# PLANNING COMMISSION MEETING

2. 23-020 DR/CUP/VAR/FSH/TREE Sandy Community Campus Park

**Meeting Type:** Planning Commission  
**Meeting Date:** September 25, 2023  
**From:** Kelly O'Neill Jr.  
**Subject:** 23-020 DR/CUP/VAR/FSH/TREE Sandy Community Campus Park

## PLANNING COMMISSION STAFF REPORT TYPE III LAND USE PROPOSAL

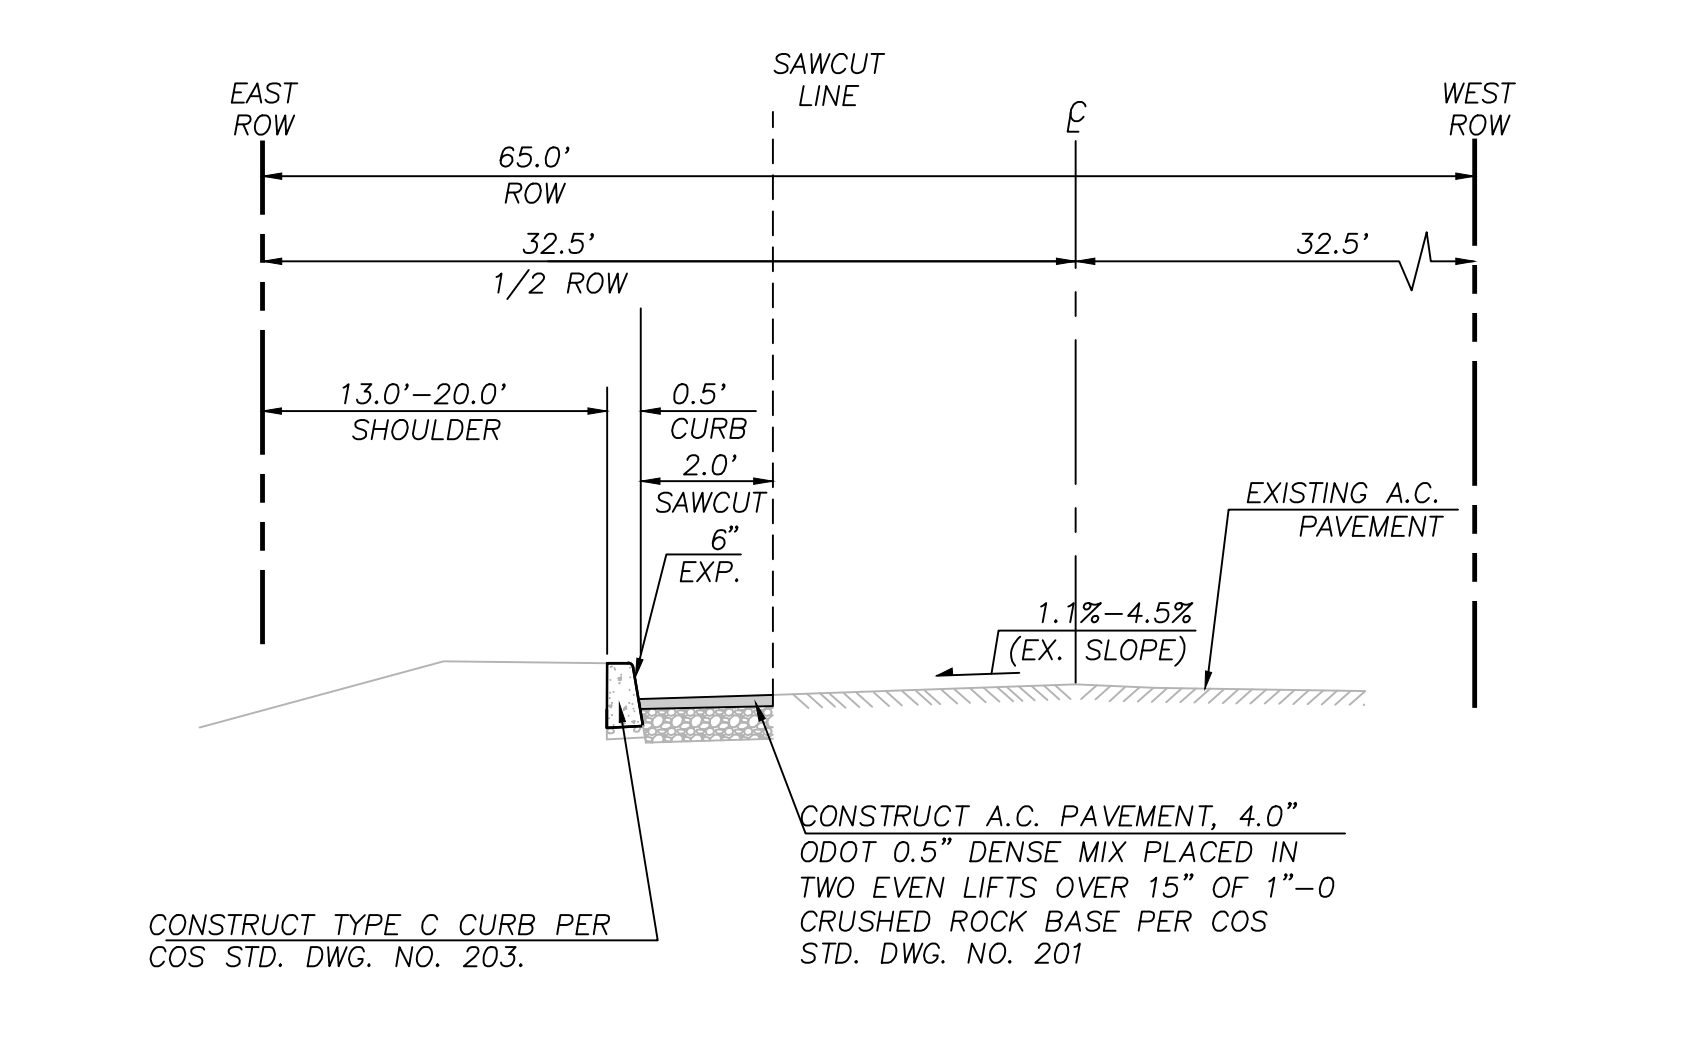
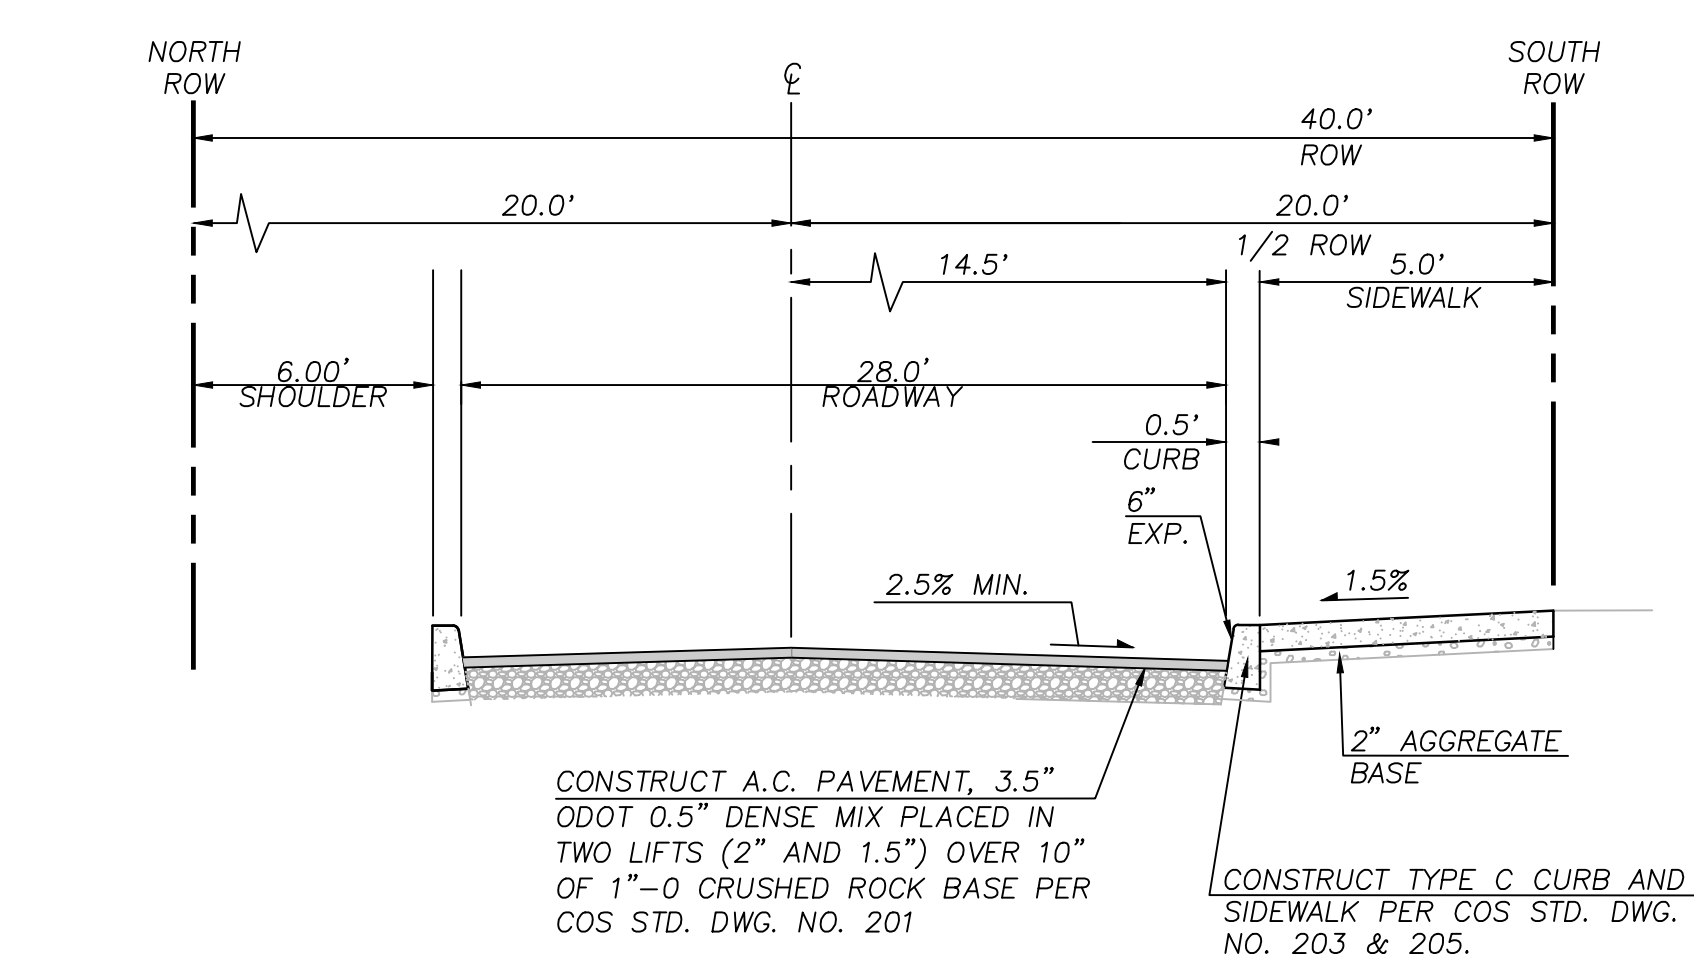
16. Chapter 17.80 requires all structures to be setback at least 20 feet on collector and arterial streets. Meinig Avenue is classified as a collector street. Scenic Street is classified as a local street. The Plan Set (Exhibit C, Sheet C2.00) details the structures further away than 20 feet from Meinig Avenue in conformance with Chapter 17.80.

96. Section 17.98.120(F) requires wheel stops or other methods to protect landscaped areas and pedestrian walkways. The plan set (Exhibit C, Sheet C2.00) details three wheel stops along the ADA parking spaces at the location of a flush curb. The remainder of the parking spaces are internal to the parking lot and do not warrant a wheel stop.

38. Section 17.90.120(A)(5) and (8) require raised or painted pedestrian crossings in parking lots. **The applicant shall revise the plan set to detail a driveway apron or other delineated pedestrian crossing at the driveway on Meinig Avenue that connects the sidewalks on each side of the driveway.**
